ADDENDUM NUMBER ONE

PROJECT: Gilham Elementary School Renovation and Expansion Phase 01
TO: Plan Holders and Plan Centers
FROM: GMA Architects
860 West Park Street Suite 300
Eugene, OR 97401
SUBJECT: Changes, Revisions, Clarifications, and Additions
DATE: 26 February 2016

13 PANEL JOINT
1 1/2" = 1'-0"

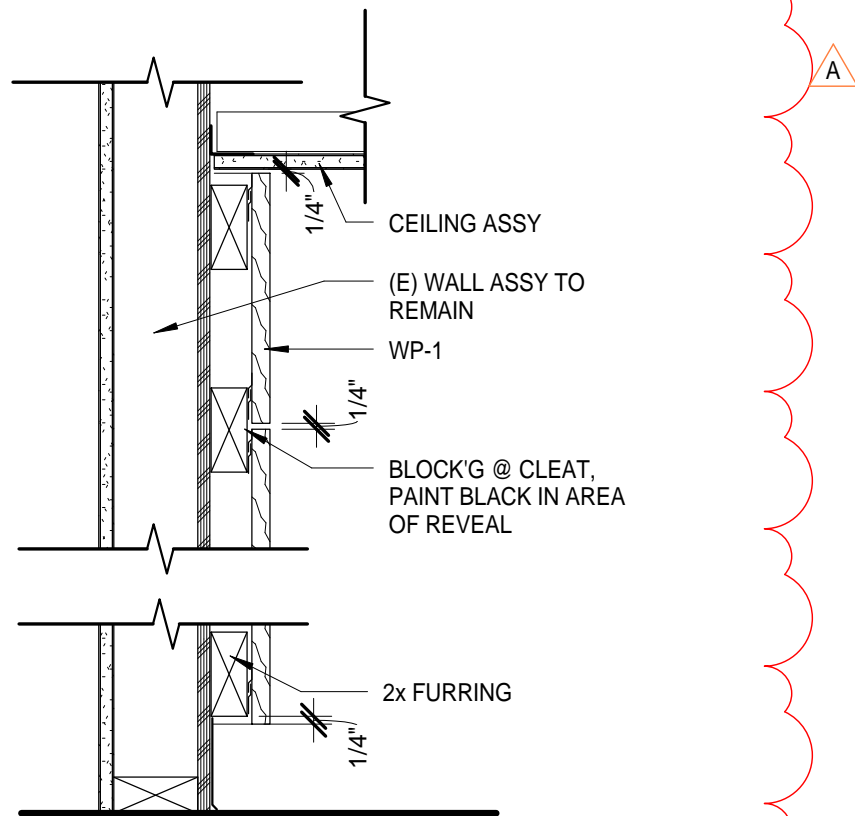
Add: Drawing 13/ADD-1.12, attached.

1 PANEL FURRING 1
1 1/2" = 1'-0"

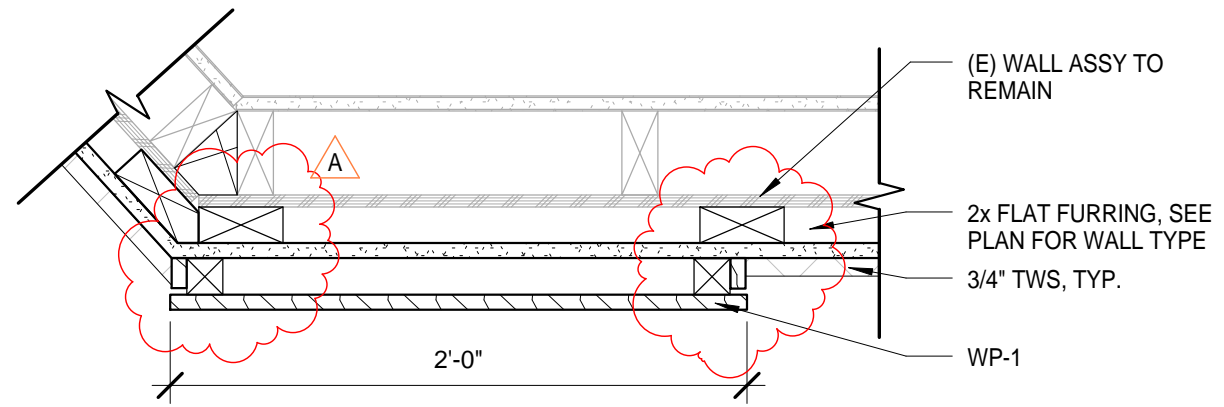
Delete: Drawing 1, 2, 3 and 6.

Add: Revised Drawing 1/ADD-1.12, 2/ADD-1.12, 3/ADD-1.12 and 6/ADD-1.12, attached. Revisions are clouded.
